First Solar FS Series Module Clip Compatibility

Compatibility of Sikla PVG-M / PVG-E with FS Series 2 Modules

Release of Sikla PVG-M / PVG-E

Figure 1: Sikla PVG-M (Mid Clip)

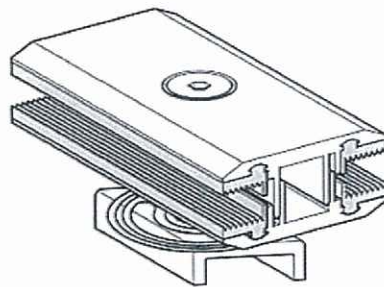
The Sikla PVG-M / PVG-E in conjunction with FS Series 2 module laminates has successfully met the First Solar mechanical load test. The proposed mounting system design in conjunction with FS Series 2 module laminates also meets the technical requirements concerning clip design that are specified in document PD-5-320 (see Figure 1 and Figure 2 below).

Therefore, the Sikla PVG-M / PVG-E in conjunction with FS Series 2 module laminates is approved for use as long as the mounting system complies with First Solar's technical and mechanical requirements for mounting systems, as described in document PD-5-320.
